**Re: Hyde Park Office
4272-4274 Albany Post Rd.
Tax ID #6064-02-933017
Site Plan Application**

Below are responses to comments prepared by the Zoning Administrator in a letter dated January 31, 2022:

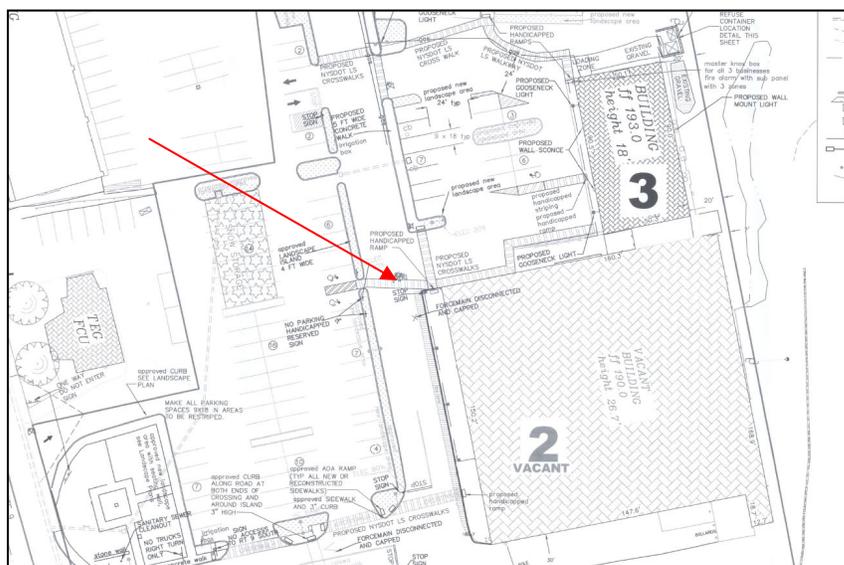
12. *Wall pack lighting of the north side of building 2 overlaps a bit with the site lighting associated with Phase II. Add the wall pack fixture details and lumens/light spectrum range detail of the wall pack to the lighting plan.*

Response: Per Berger Engineering, “see Amended Site Plan Set dated March 21, 2022.”
